Project Addresses: 306 N Brooks Street
Application Type: Demolition Permit, Zoning Map Amendment, Conditional Uses, and Certified Survey Map Referral
Legistar File ID # [83527](#), [83907](#), [83529](#), and [83531](#)
Prepared By: Chris Wells, Planning Division
Report includes comments from other City agencies, as noted
Reviewed By: Kevin Firchow, Planning Division

Summary

Proposal Summary: The applicant is seeking approvals to construct 15-story, 189-unit apartment building at the northwest corner of W Johnson Street and N Brooks Street following demolition of a four-story lodging house. The underlying lots comprising the subject site will be combined into one lot by CSM. The letter of intent indicates that construction will commence in December of 2025, with completion anticipated in June of 2027.

Image 1: Building Heights Surrounding the Subject Site. (Source: Vierbicher Associates)

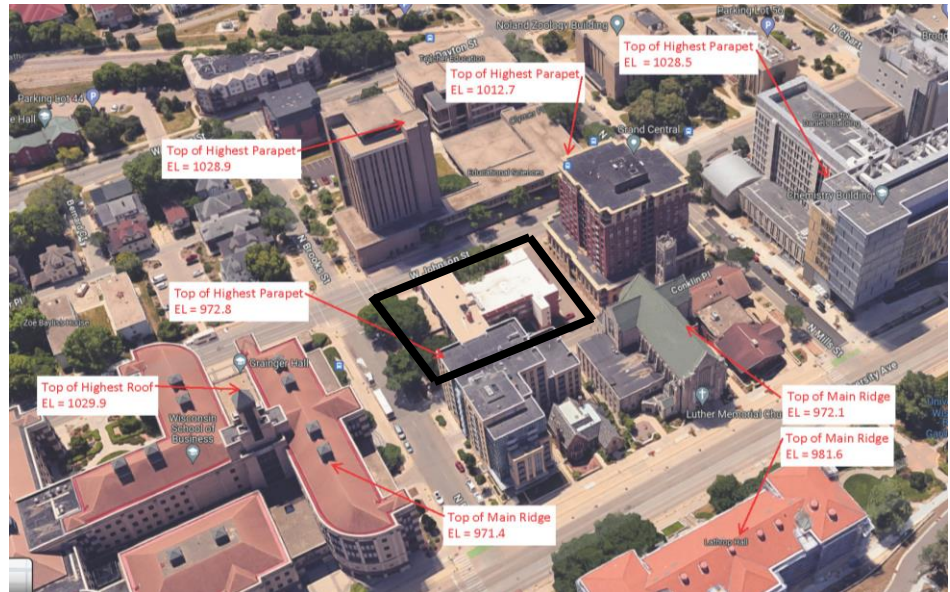
As a measure of building scale, staff have used building height as a proxy. The proposed building height is roughly 161 feet, which equates to roughly 1,032 feet above sea level. (The Capital View Preservation height limit is 187.2 feet above City datum or 1,032.8 ft above sea level). For comparison’s sake, the applicant team prepared a building height survey of the surrounding parcels (see Image 1 below).

North: Across Conklin Place is X01 Apartments, a nine-story, 79-unit apartment building, whose height reaches up to roughly 1,013 feet and Luther Memorial Church, which rises up to the roughly 972-foot mark;

South: Across W Johnson Street is the University of Wisconsin’s roughly 11-story Educational Sciences building, which reaches up to the roughly 1,029-foot mark;

West: The 12-story, 179-unit, Grand Central apartment building, which reaches up to the 1,013-foot mark, beyond which is the University of Wisconsin’s Chemistry Building, which reaches up to the roughly 1,028-foot mark; and

East: Across N Brooks Street is University of Wisconsin’s five-story Grainger Hall whose roof ridge reaches up to the 971-foot mark but whose tower spire rises to the 1,029-foot height mark.

This means that there are three buildings located in the surrounding block (four if you count the Grainger Hall spire) that rise up to at least the 1,012-foot mark (or within roughly 20 feet of the proposed building), two of which rise up to less than five feet of the proposed building. Furthermore, the proposed building’s mass and stepbacks closely resembles that of the adjacent Grand Central apartment building to the west which also has a roughly five-story base before stepping back on all sides.
